Technical Service Bulletin

Product Category	Model(s) Affected	Date Issued
Sanitizers	IntelliChlor Plus & LT SCGs IntelliCenter / IntelliChlor Plus40 Bundles 523741; 523747; 523730; 523735; 523738; 523744; 523750; 523733; 523744-EC; 523747-EC; 523735-EC; 523770; 523961; 523962; 523964; 523965; 523966; 523967; 523968; 523969; 523914; 523963	October 27, 2025
Topic		Bulletin Number
HMI Controller Assembly Firmware Update – from 1.003 to 1.004		A00709

Firmware Update Notification – IntelliChlor Plus/LT HMI Controller

REMOVING THE EXISTING CONTROLLER

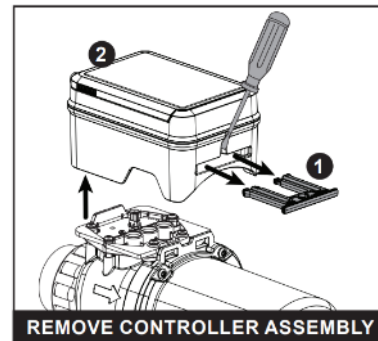
1. Disconnect all power to the filter pump, automation controls and SCG at the main breaker.

2. Using a flat blade screwdriver, gently pry the *Retaining Clip (1)* from the *Controller Assembly (2)* and place it aside.
3. Gently lift the *Controller Assembly (2)* from the cell and place it aside in a dry area.

NOTICE Shifting or shimmying the Controller Assembly side to side during removal may damage connection terminals. Only lift upwards.

INSTALLING A NEW CONTROLLER

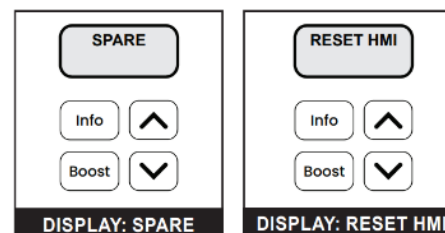
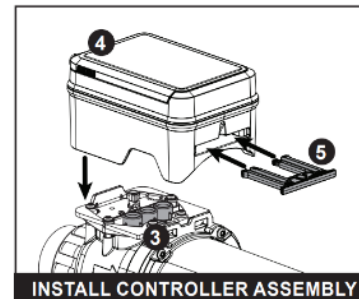
1. Using the provided dielectric grease, thoroughly coat all three *Sensor-Controller Connections (3)*.
2. Place the *Controller Assembly (4)* onto the cell and gently push down to ensure connections are tight.
3. Reinstall the *Retaining Clip (5)* and ensure the *Controller Assembly (4)* can no longer be separated from the cell body.
4. Reestablish power to the filter pump, automation controls and SCG at the main breaker.
5. After repowering, the controller will display one of following messages:

- **SPARE:** No further action is needed. The controller will automatically sync historical and run-time data with the cell.
OR;
- **RESET HMI:** Controller must be manually RESET before it can pair to the cell. Continue to the *Pairing a Previously-Used Controller (Reset HMI)* section below.
